# Service-Information Motorcycle

Group: 31  
Front Forks

September, 1988  
31 023 88  
(2326)

## Noisy Upper Fork Spring Support - '85 R65, R80, R100 Models

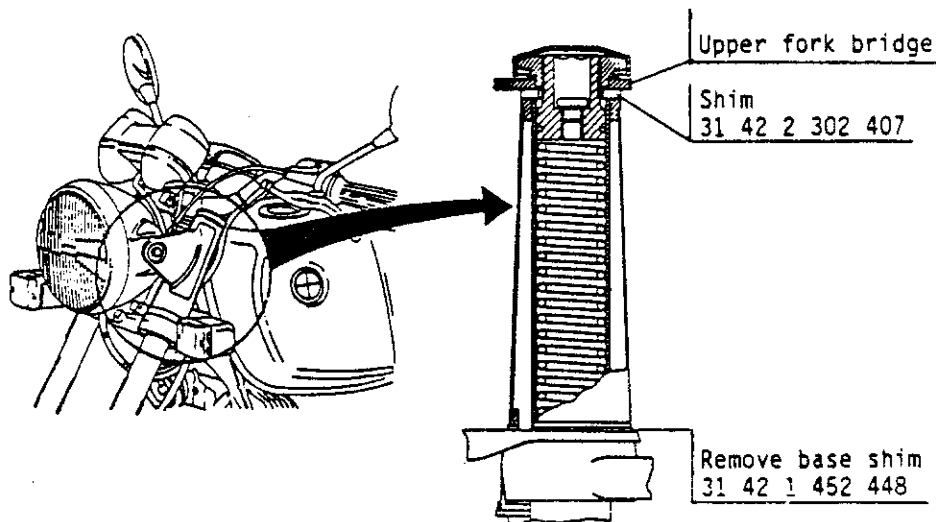
**Problem:** The fork spring support nut might work loose at the top fork bridge, causing an audible rattle.

**Cause:** The fork tube radius is pressing into the top fork bridge.

**Remedy:** Should this condition occur, install a shim:

Part no. 31 42 2 302 407

between the fork tube and top fork bridge to prevent the tubes from pressing into the casting.

**Important:**

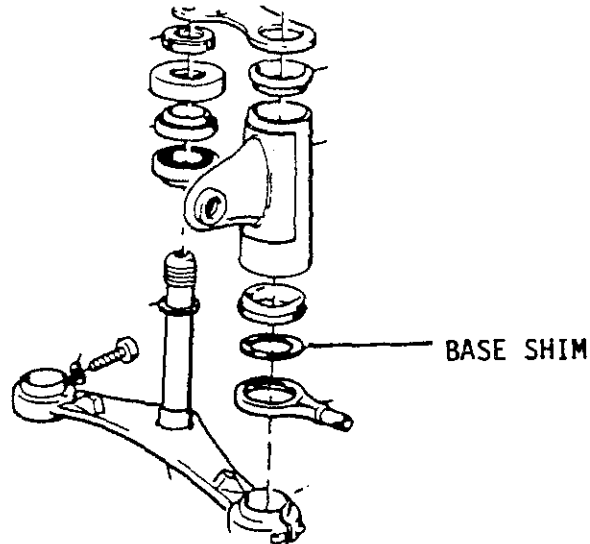
The headlight holders on the basic R65 and R80 are secured between the upper and lower bridge with rubber rings. A base shim - part no. 31 42 1 452 448 - must be removed to reduce tension.
